CHICK-FIL-A
BRASELTON HWY 53
124 SERD WAY
BRASELTON, GA 30517

FSR#05927

SHEET
EXHAUST HOOD ELEVATIONS
SHEET NUMBER
M-201

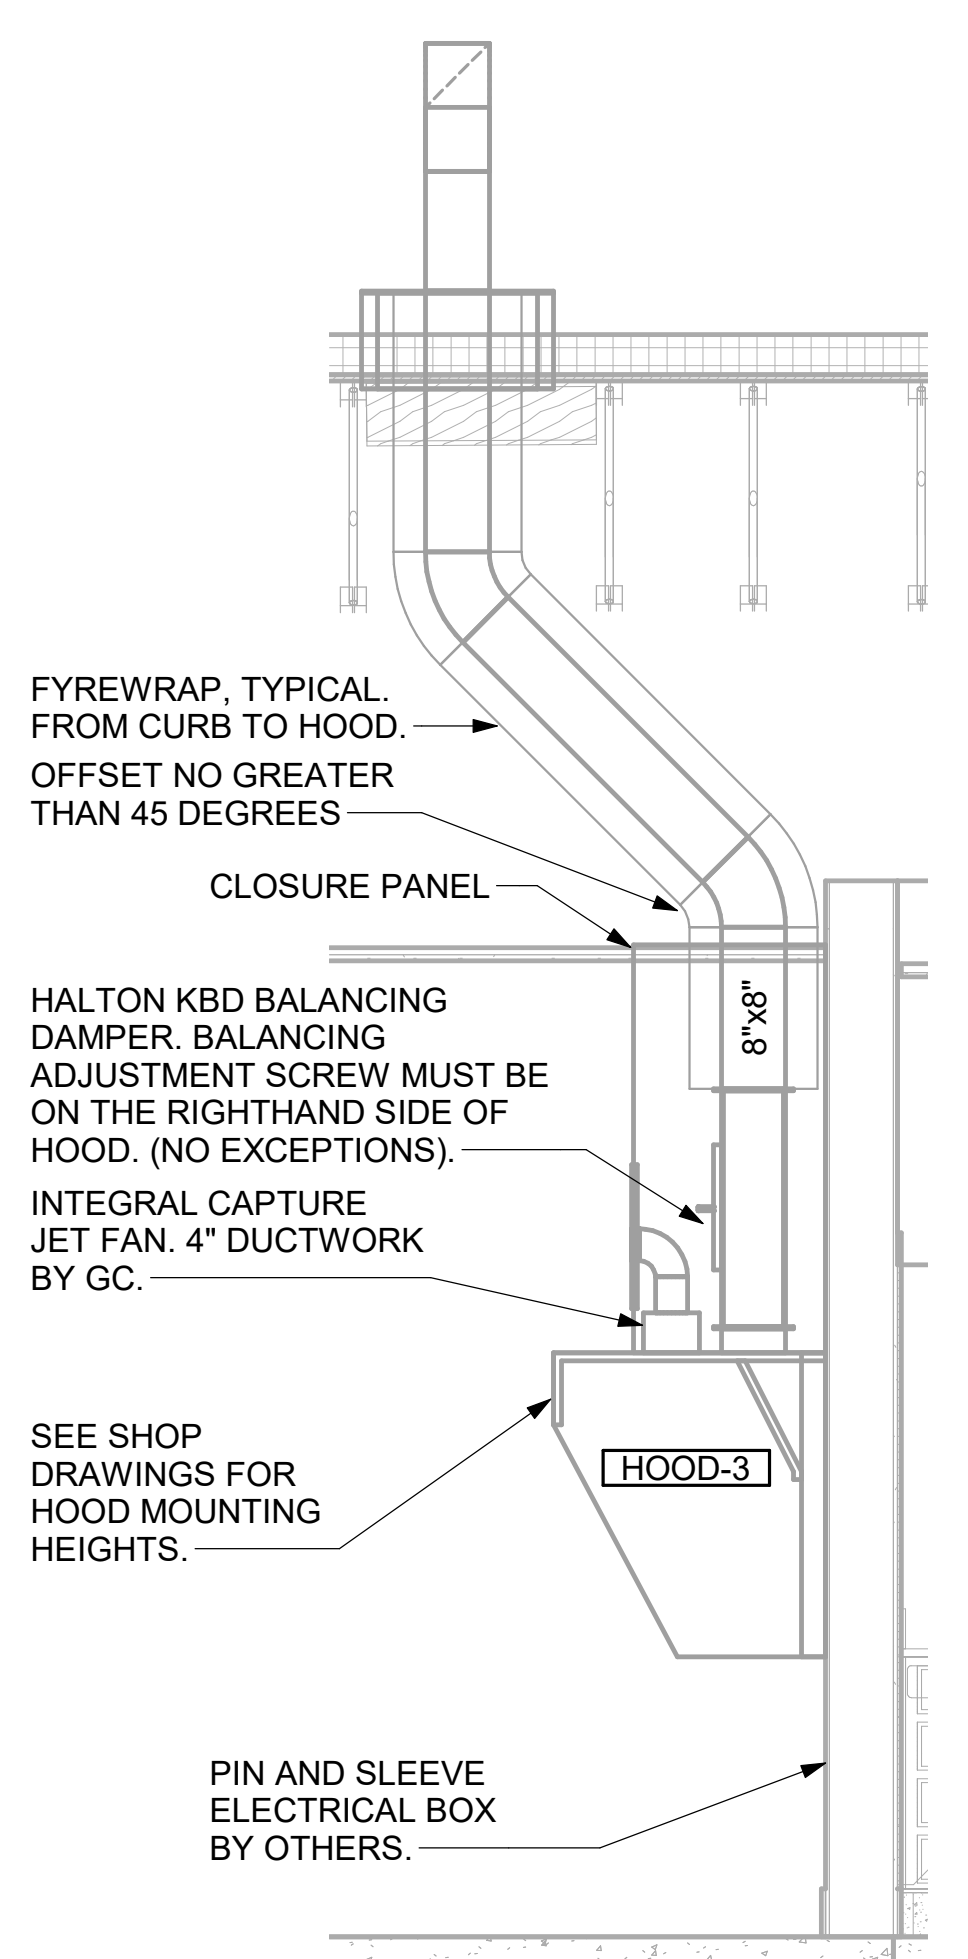
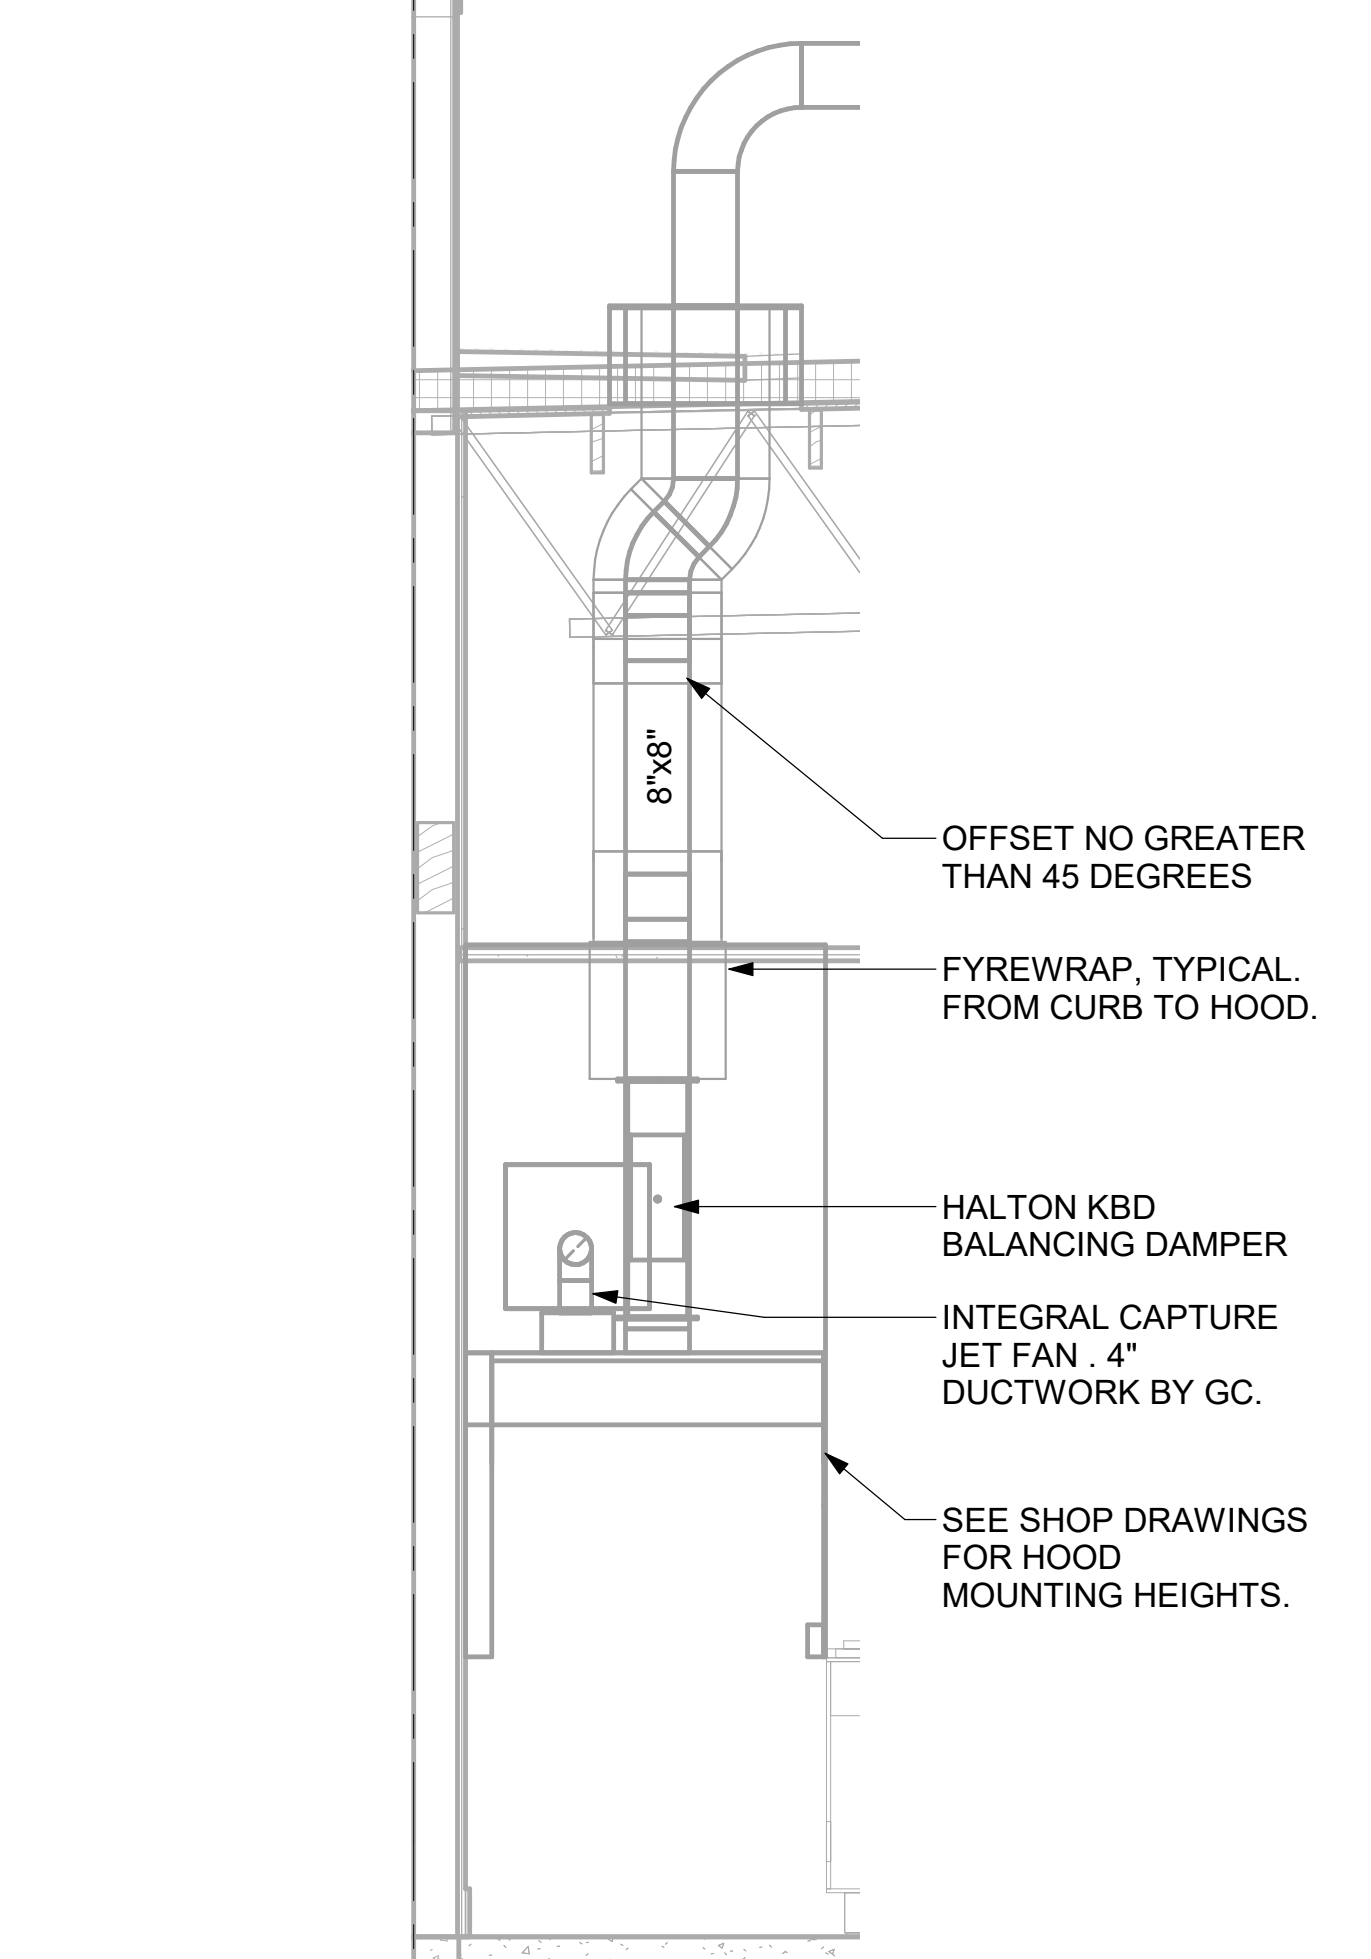
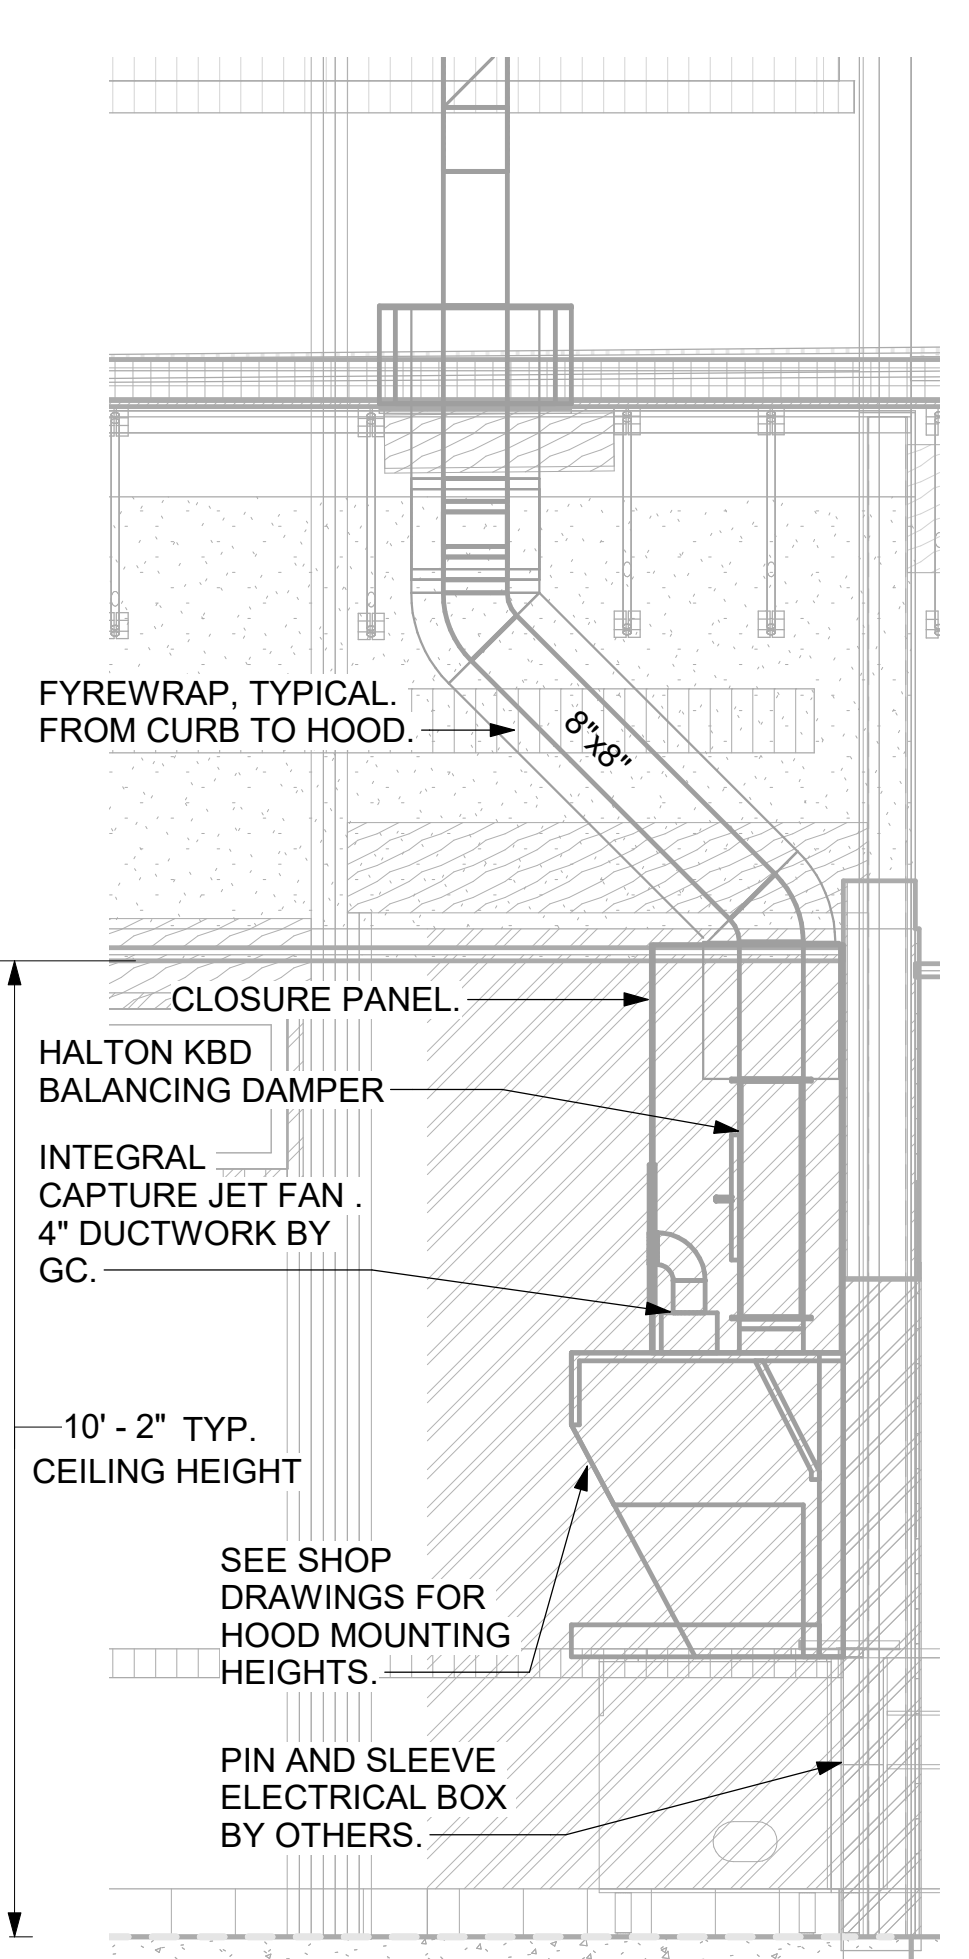
FIRE INSPECTOR COMMENTS:

1. THE KITCHEN SUPPERSSSION SYSTEM WILL REQUIRE A BALLOON TEST TO BE WITNESSED BY THE AHJ.
2. THE KITCHEN HOOD SYSTEM WILL REQUIRE A HOOD LIGHT TEST TO BE WITNESSED BY THE AHJ.
